**BIDDING AND CONTRACT REQUIREMENTS
ADDENDUM NUMBER 1**

To: Prospective Bidders
Re: **ADDENDUM NUMBER 1 TO THE BIDDING DOCUMENTS FOR:**

**Oak Brook Park District
Central Park West Mechanical Renovations**
Architect's Project Number: 220005.00

1. At drawing 1/M-101, titled, "First Floor HVAC Demolition Plan".

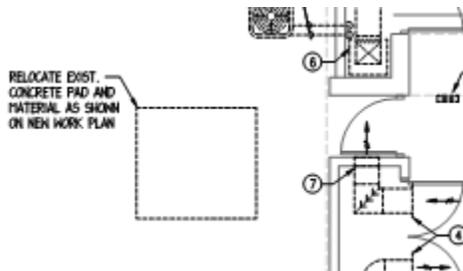
a. REVISE note to read as follows:

- 1) "Existing concrete foundations to be removed – Salvage existing wood framed screen and relocate at the owners discession", in lieu of "Relocate existing concrete pad and material as shown on new work plan." – See snapshot of existing note location below.

1 FIRST FLOOR HVAC PLAN
1/8" = 1'-0"

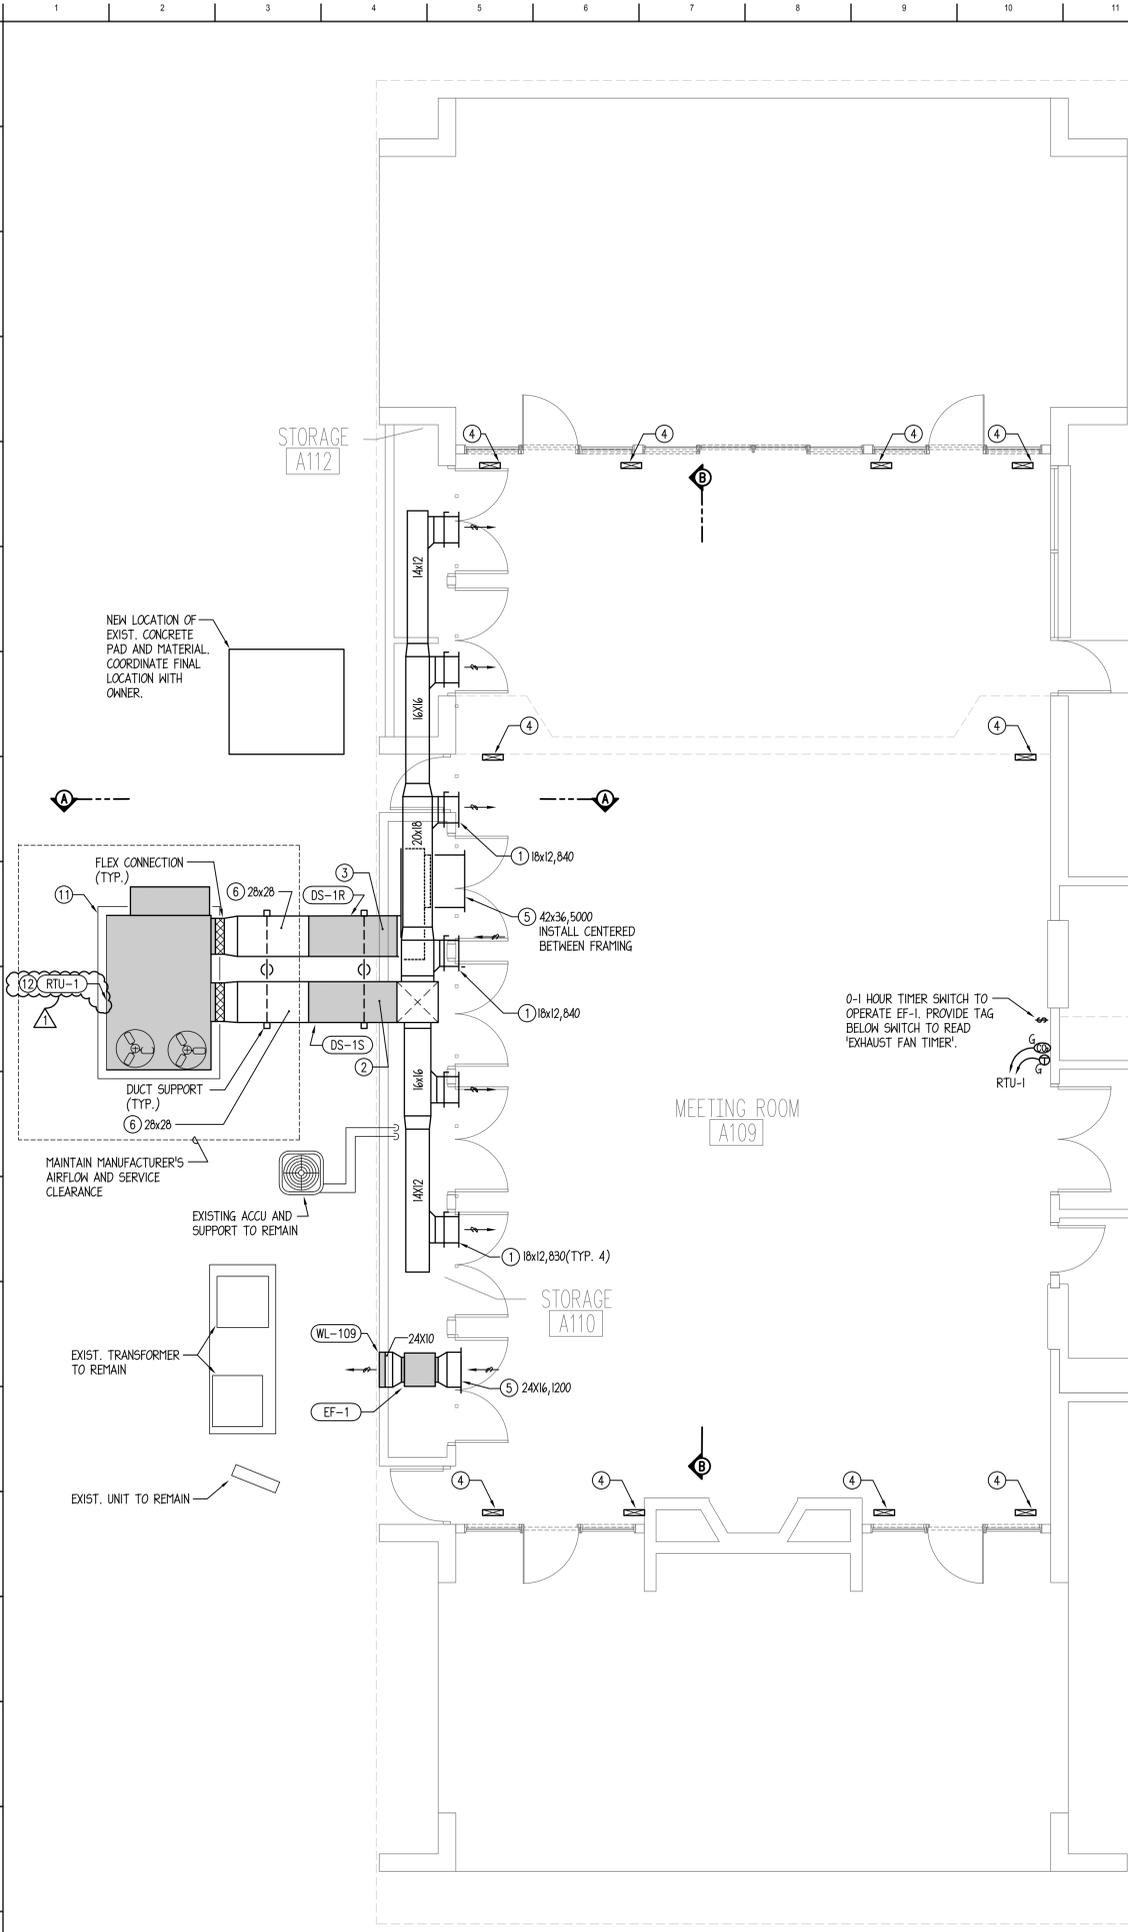
1. At the Equipment Schedule
a. DELETE equipment tag labeled "RTU-1" and all associated notes with it.
2. On sheet, near the Equipment Schedule.

- a. ADD schedule labeled, "Pre-Purchased Equipment Schedule:"
 - 1) ADD equipment tag labeled, "RTU-1" and all associated notes with it.
3. At the Drawings Notes
 - a. ADD the following notes:
 - 1) "12. Unit Pre-Purchased by owner and installed by contractor."

- 11 4" THICK REINFORCED CONCRETE PAD WITH 4" CRUSHED GRAVEL BASE 6" LARGER THAN UNIT IN ALL DIRECTIONS.
- 12 UNIT PRE-PURCHASED BY OWNER AND INSTALLED BY CONTRACTOR.

PRE-PURCHASED EQUIPMENT SCHEDULE:

RTU-1 12.5 TON TRANE VOYAGER 'TH180G' PACKAGED ROOFTOP UNIT ON GRADE TO DISCHARGE 5,000 CFM AT 1.0 ESP, 2378 LB., 54 KW ELECTRIC HEATING CAPACITY, AND DEHUMIDIFICATION SEQUENCE, 88.9°F HEATING LAT, 60.7°F DB/56.0°F WB COOLING LAT, 240V/1 HIGH ϕ , 155 MCA, 175 MOCF. PROVIDE MANUFACTURER'S 24" CURB, ECONOMIZER WITH BAROMETRIC RELIEF, AND SOUND ATTENUATION ACCESSORIES.
